FIRE DEPARTMENT COMMENT RESPONSE SHEET

Status: Review complete. Resubmittal required.

PZ21-12000034

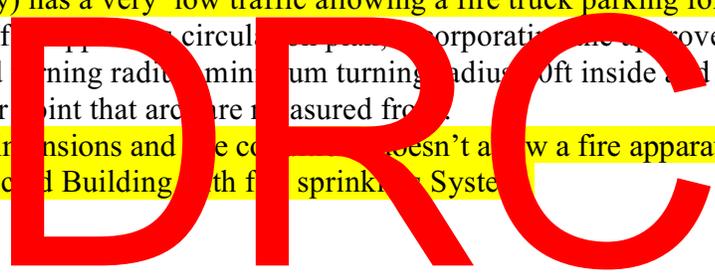
(4) Documentation of purchase for fire service backflow and meter assemblies must be provided to City of Pompano Utilities and Fire Prevention before underground inspections of water mains. Installation of assembly as per backflow/meter specifications and following standards: NFPA 13 Standards of Installation of Fire Sprinklers, NFPA 25 Standards for Inspection, Testing, and Maintenance of Water Based Fire Protection Systems. All control valves on backflow and meter assemblies, total of four (4), for fire protection systems must have fire alarm supervision (tamper switches).

R. To be submitted
